COPPERSTRING EIS

Attachment F - Vegetation Clearing Works plans

Dajarra Road to Mount Isa

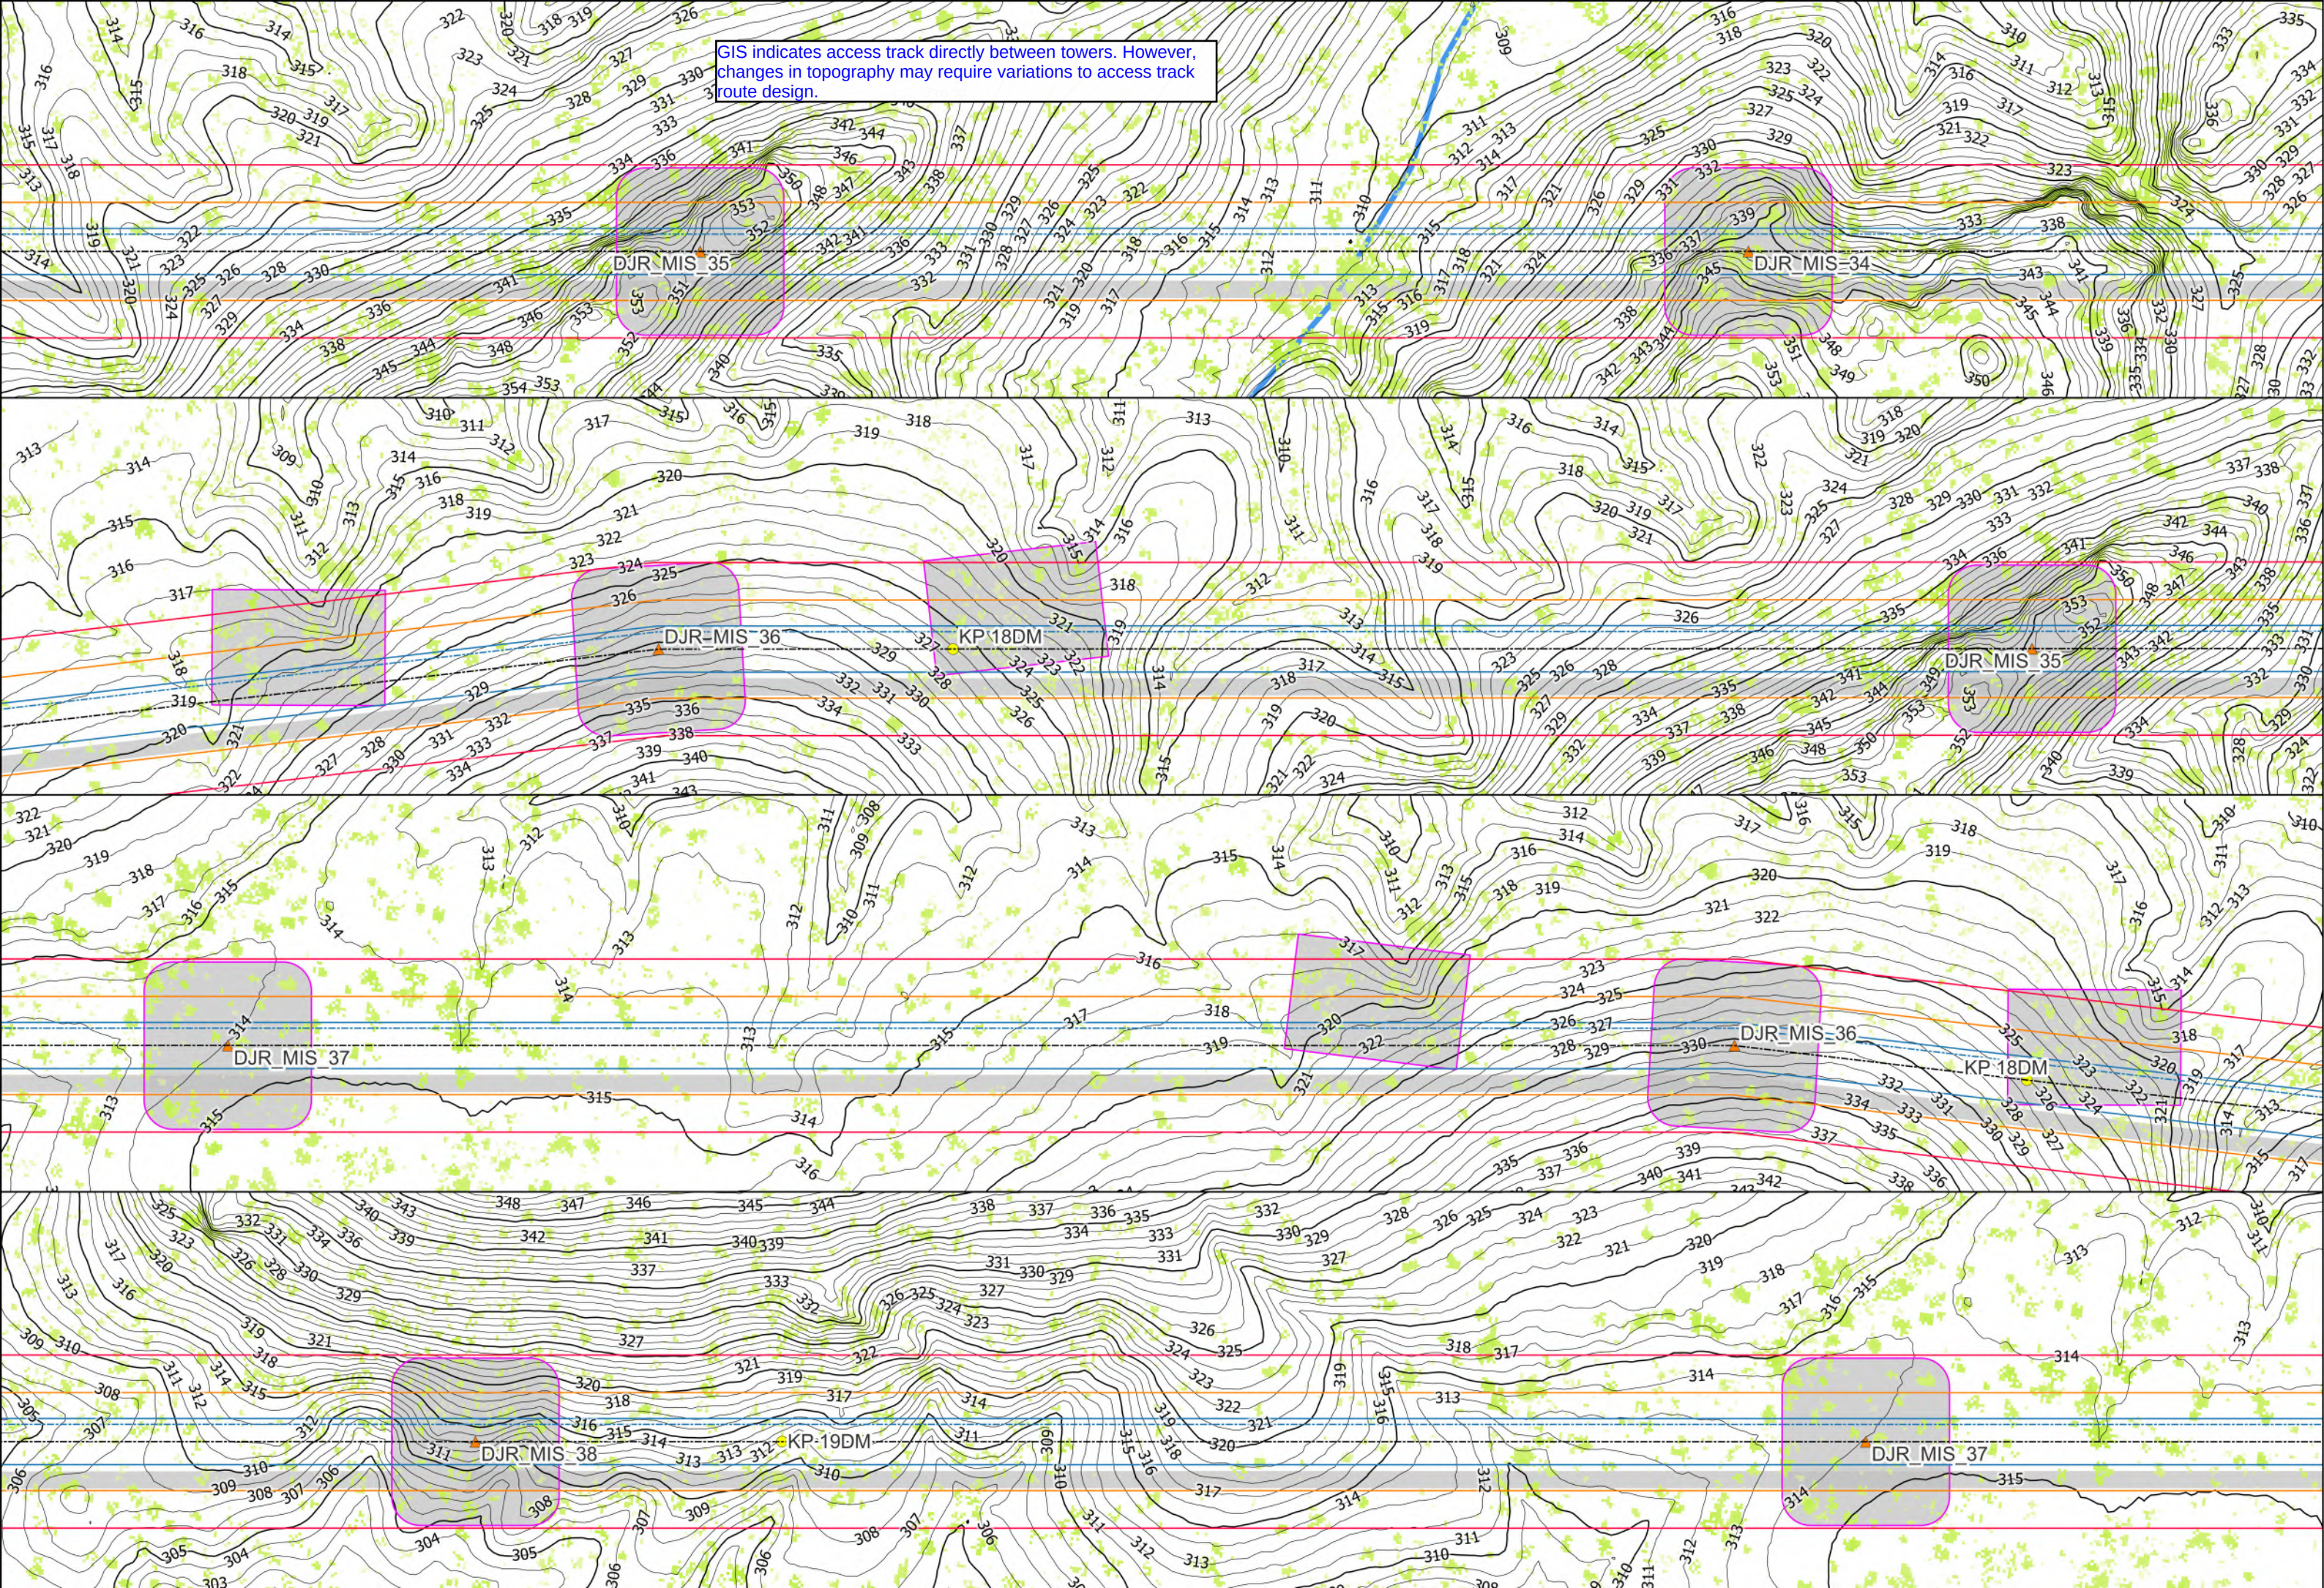
GIS indicates access track will occur outside of easement due to large changes in topography.

GIS indicates access track directly between towers. However, changes in topography may require variations to access track route design.

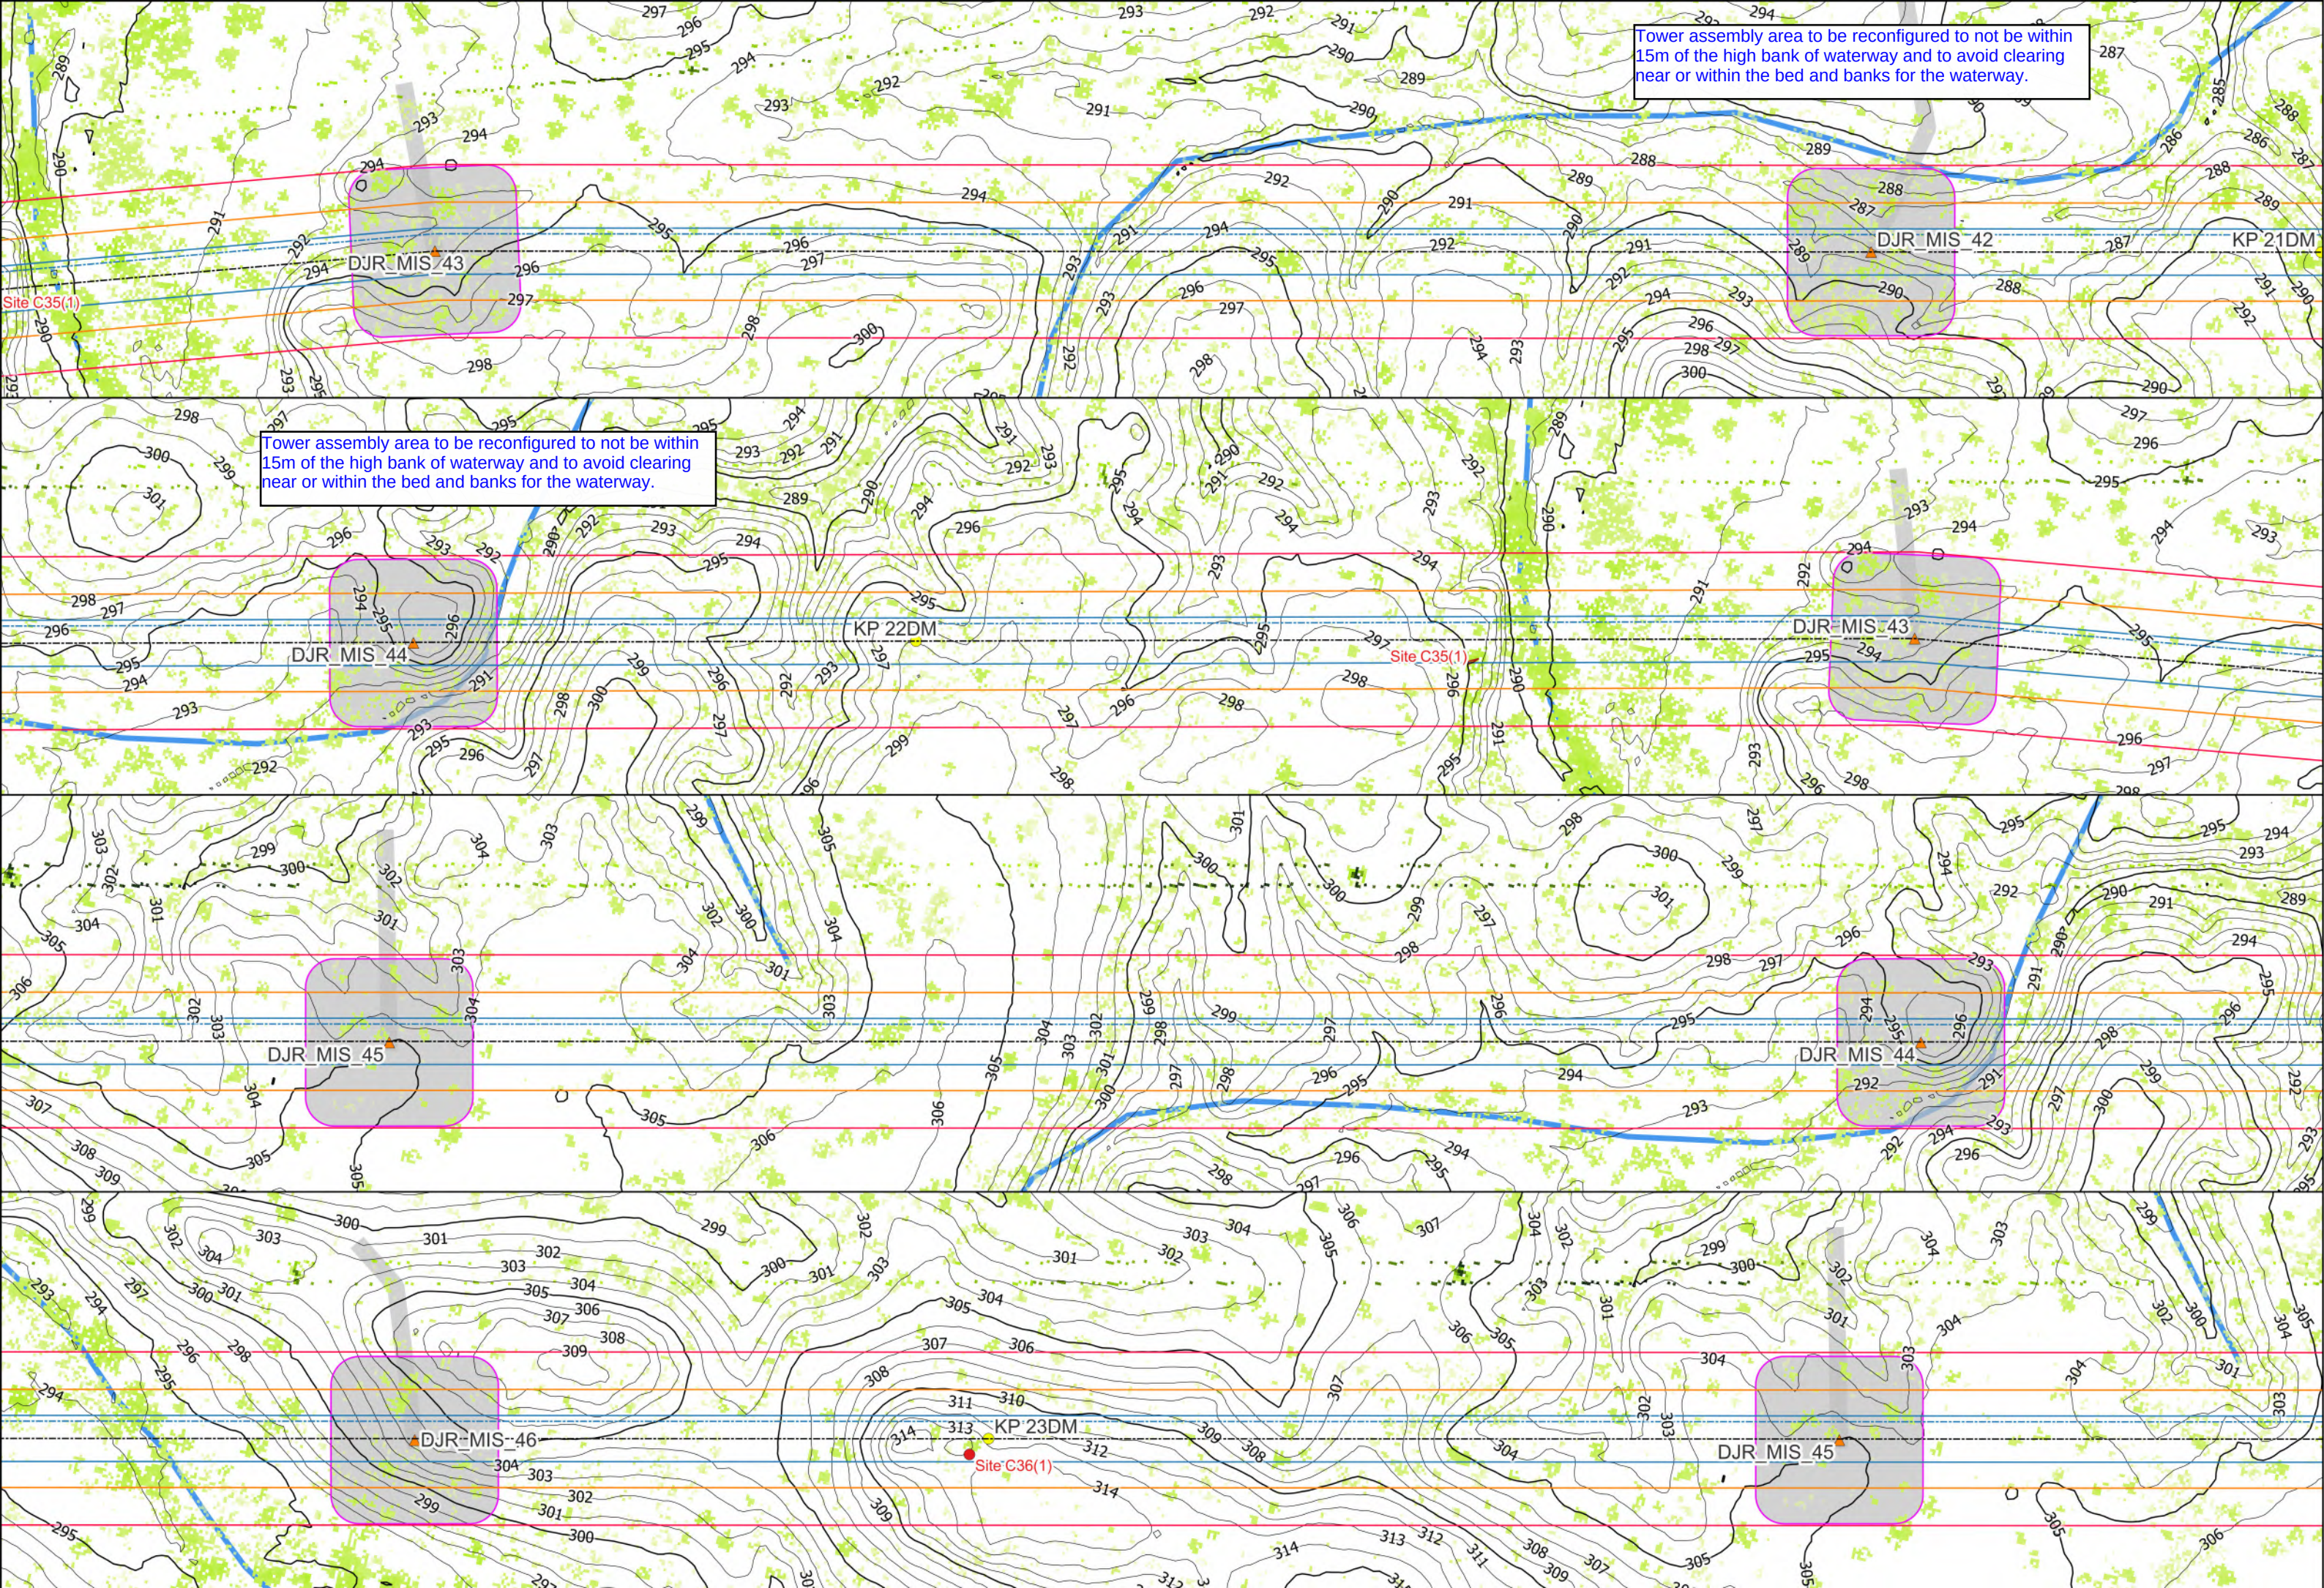
Tower assembly area to be reconfigured to not be within 15m of the high bank of waterway and to avoid clearing near or within the bed and banks for the waterway.

Tower assembly area to be reconfigured to not be within 15m of the high bank of waterway and to avoid clearing near or within the bed and banks for the waterway.

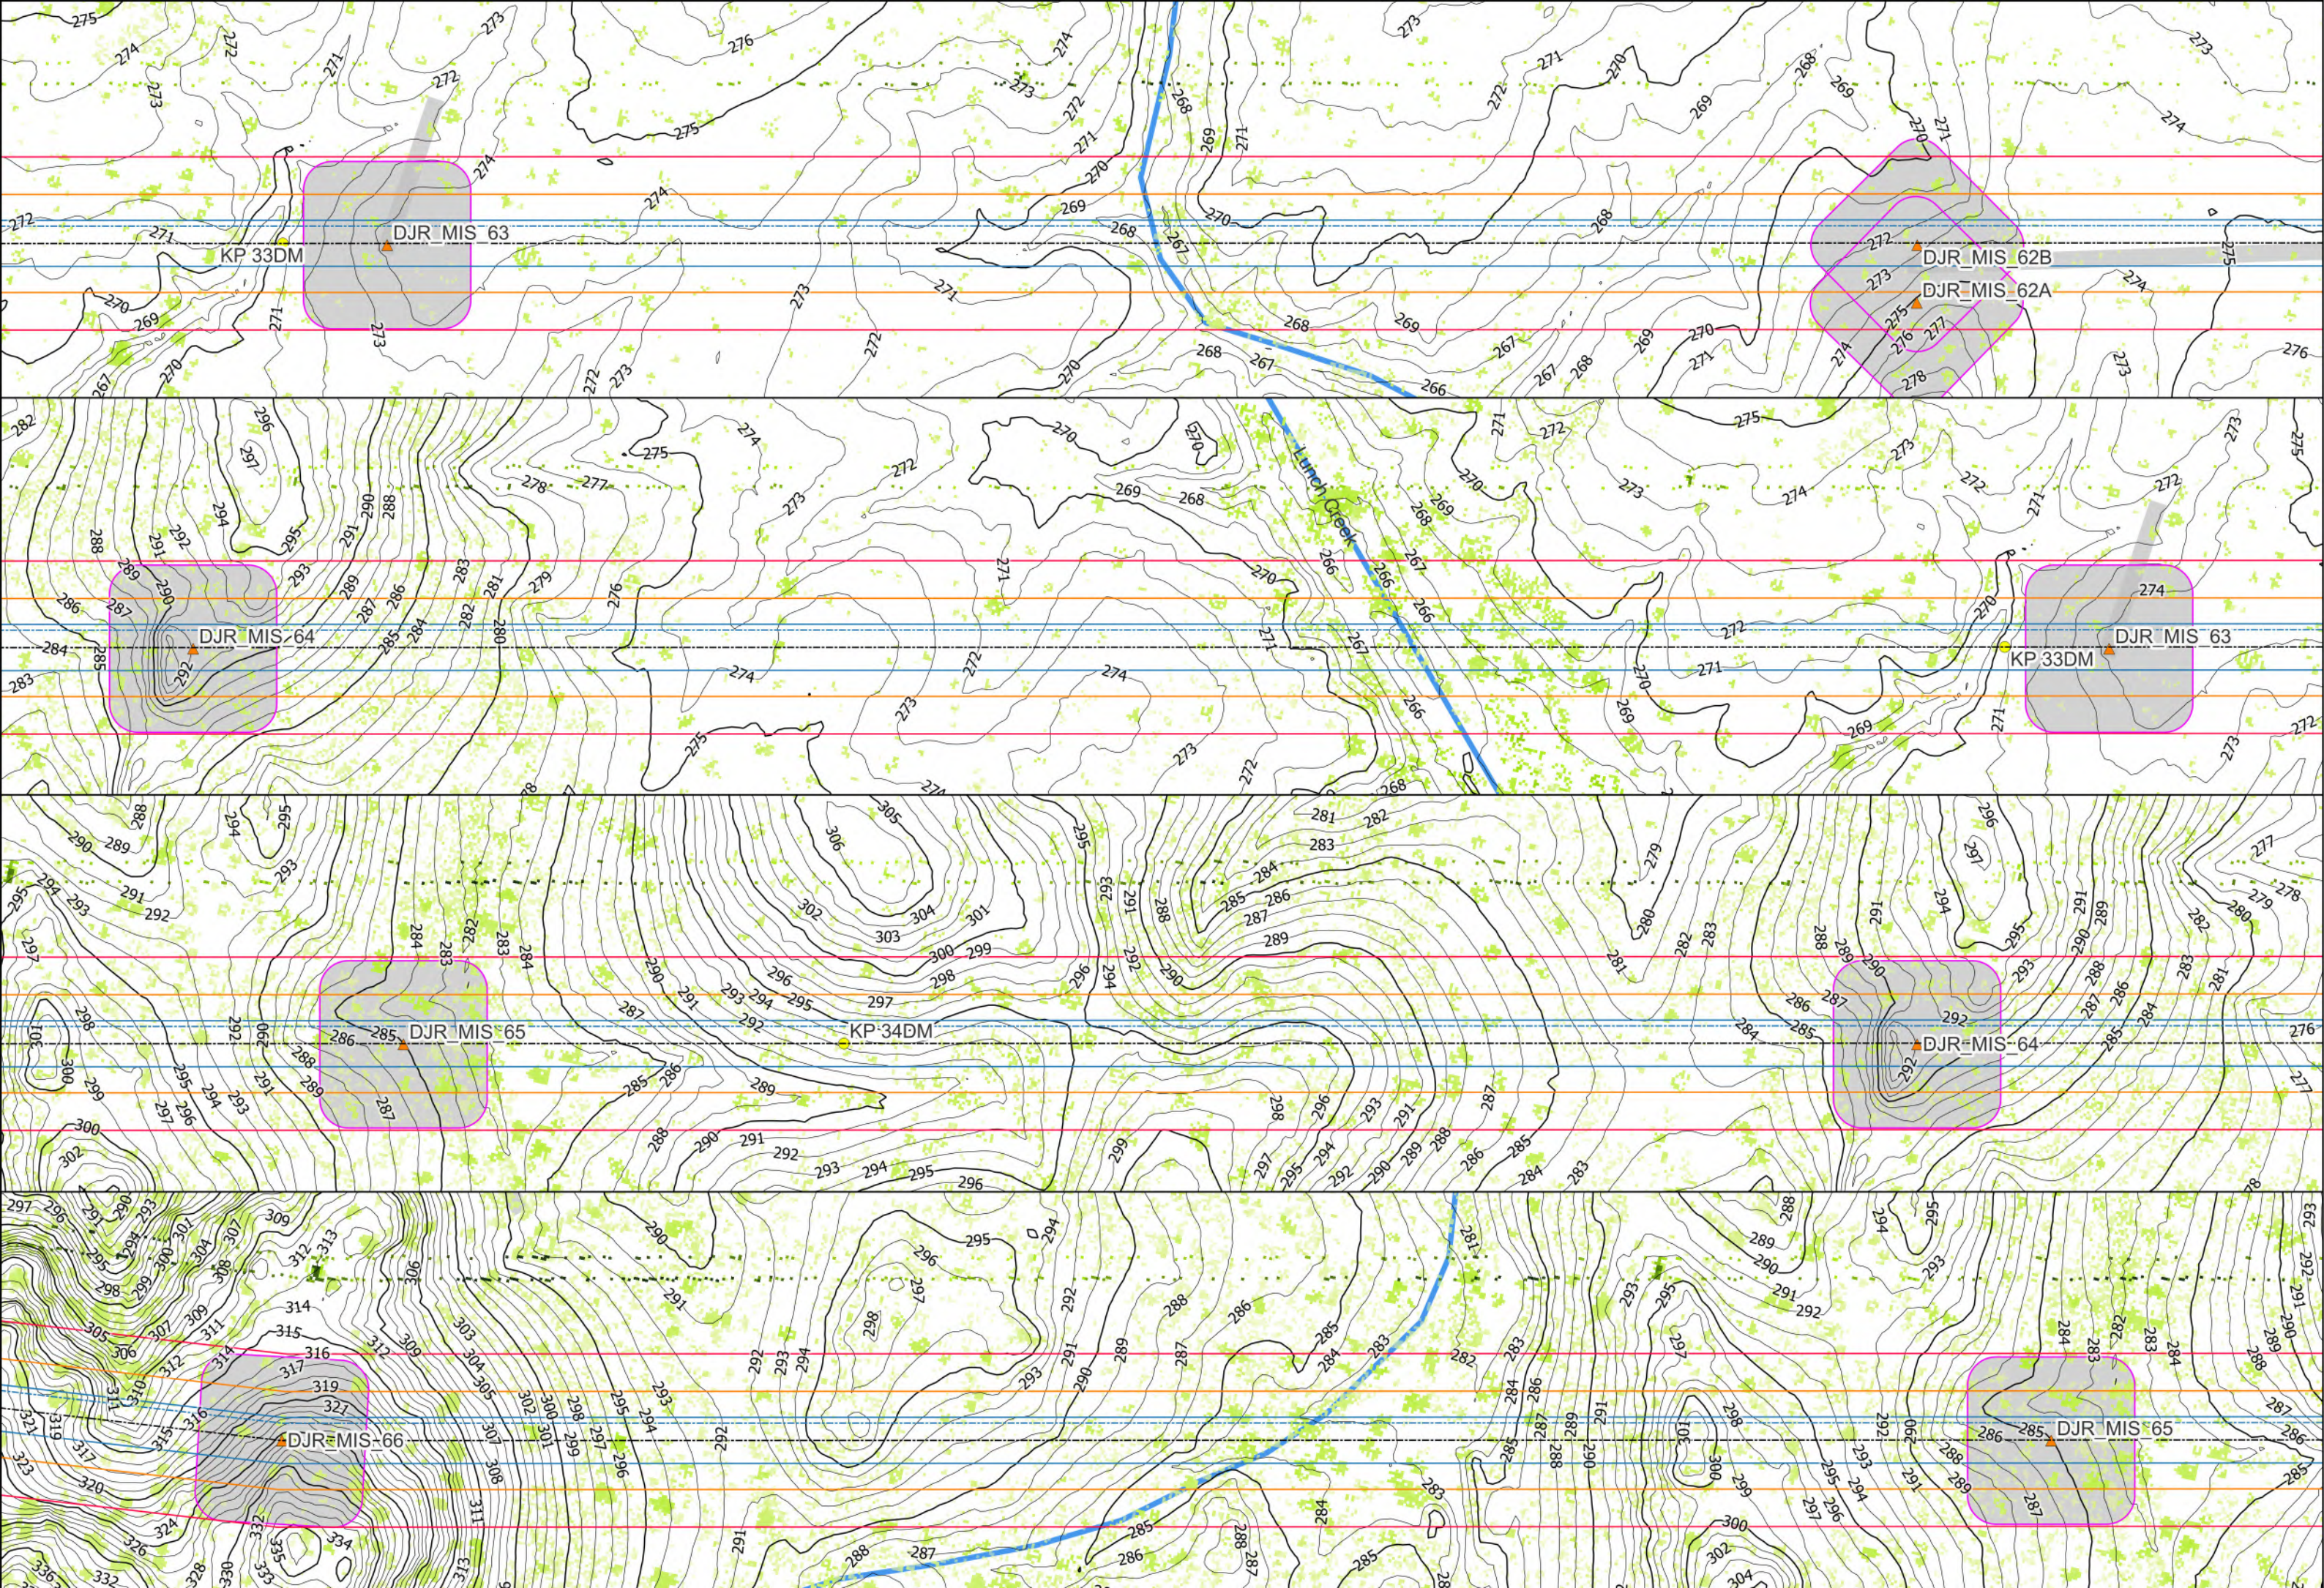
Tower height and placement to reviewed during detailed design to reduce clearing impacts to waterway. Clearing for conductor clearance to this High Risk (red) waterway occur above ground level to minimise disturbance to ground and roots which contribute to bank stability.
